**BEFORE THE LD. NATIONAL GREEN TRIBUNAL, EASTERN ZONE**  
**KOLKATA BENCH**  
**O.A. NO. 132 OF 2023/EZ**

**SUPPLEMENTARY COUNTER AFFIDAVIT ON BEHALF OF RESPONDENT NO.6**

Observations on Draft DPRFor"PREPARATION OF DETAILED PROJECT REPORT OF GAYA INTERCEPTION AND DIVERSION AND STP SCHEME UNDER NAMMIGANGE IN BIHAR, INDIA"

**REPORT OF SITE VISIT AND DISCUSSIONS WITH BUIDCO ON DRAFT DPR  
FOR INTERCEPTION & DIVERSION AND STP SCHEME OF  
GAYA, BIHAR DURING NOV 4-5, 2025**

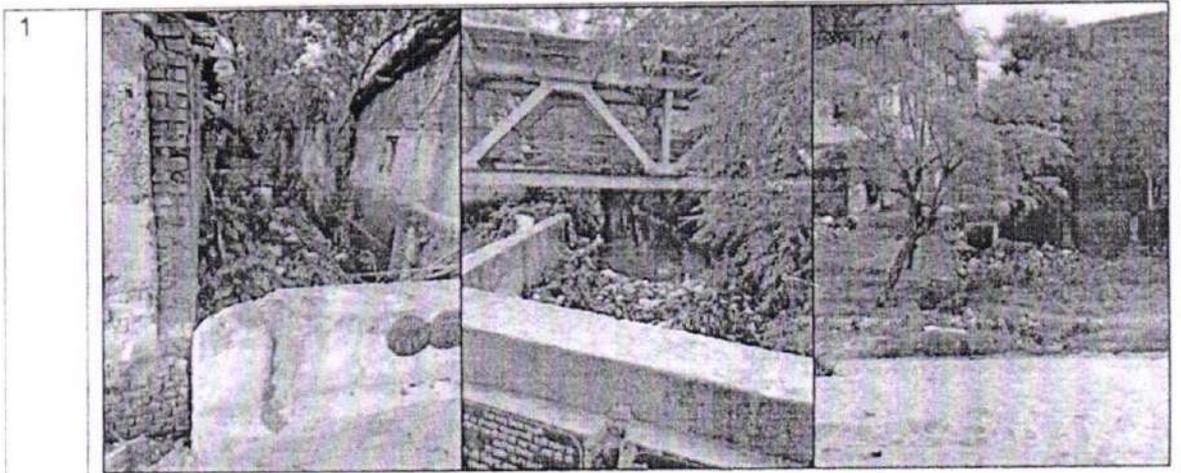
A visit to Gaya city was undertaken during November 4-5, 2025, by Prof. Ashok Kumar Gupta from the Civil Engineering Department, IIT Kharagpur, for discussions on the present status, proposals under review, and visits to the locations of open drains carrying sewage, drain outfalls into the Phalgu River, and the sites of proposed STPs. Discussions were held with the team of engineers/project directors from the Bihar Urban Infrastructure Development Corporation Ltd. (BUIDCO).

Photographs taken during the site visit, and related observations:

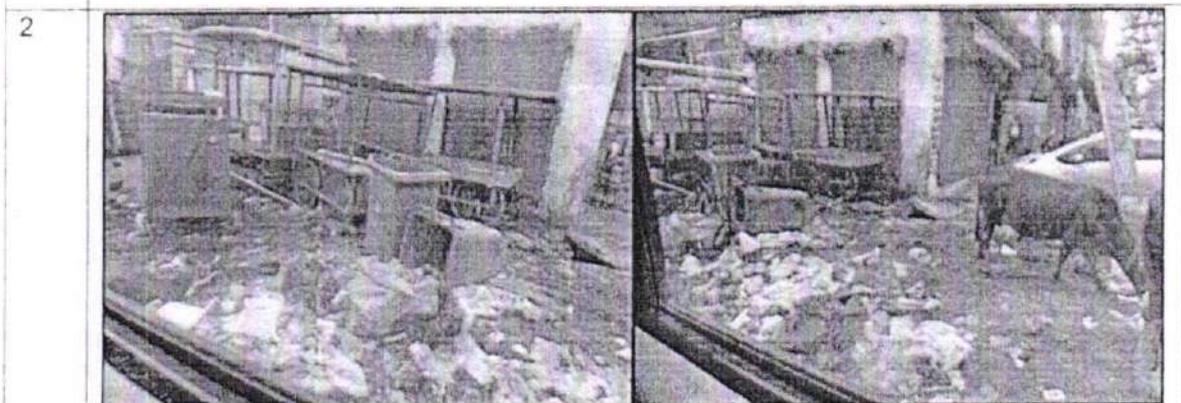
The open drains carrying sewage were observed to have reduced discharge capacities because of sediment deposition and solid waste accumulation. They showed improper slope and hydraulic gradient that resulted in stagnant conditions along several stretches. The locations showed clear evidence of waste disposal into the drains, further obstructing flow and contributing to localized pollution. The unlined sections indicate a high potential for seepage into the surrounding soil, which may lead to contamination of shallow groundwater. In addition, exposure to atmospheric conditions makes these drains susceptible to evaporation losses.
